Item 6 -Cape Coral Evacuation Study

Some older Scans regarding Proposed I-75 Interchange

IS THERE ANYTHING RIGHT ABOUT DEL PRADO/I-75?

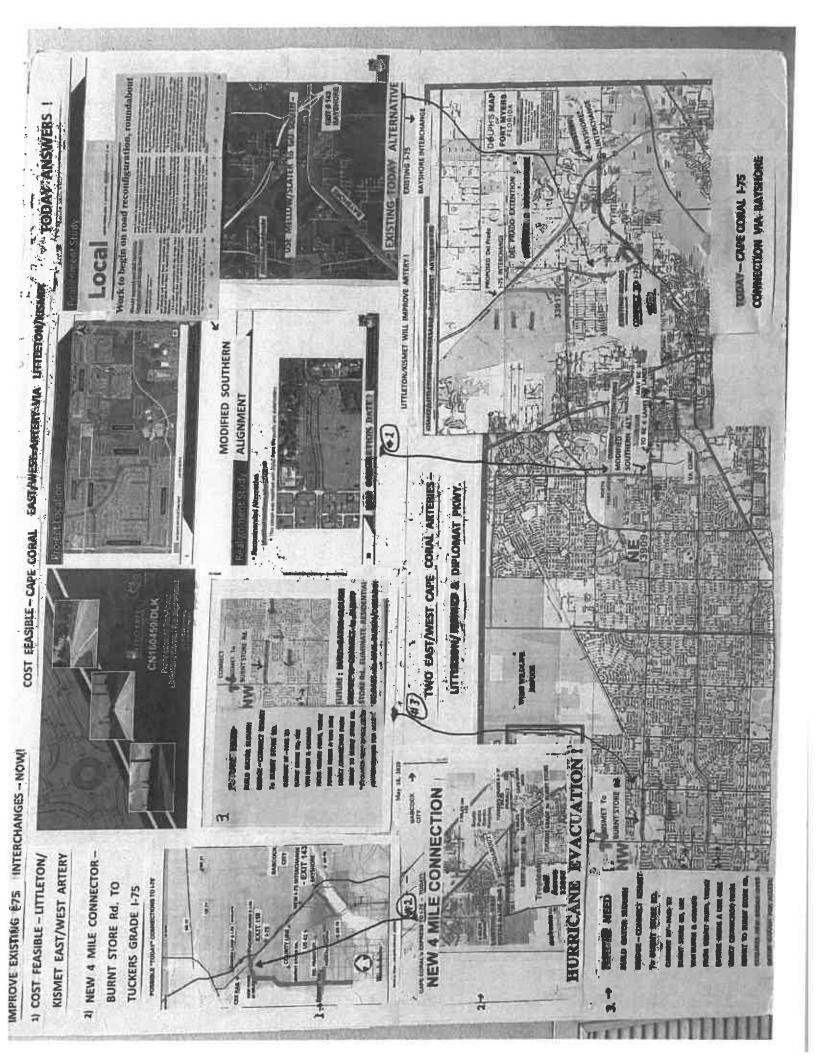
Four – I call this graphic scale map "Del Prado – Outdated & Unaffordable"! Actually going South— it is approximately the same (about FIVE miles) distance if one uses the EXISTING Mellow/Slater route to Exit # 143 than if one came to the same point via the proposed COSTLY Del Prado Interchange.
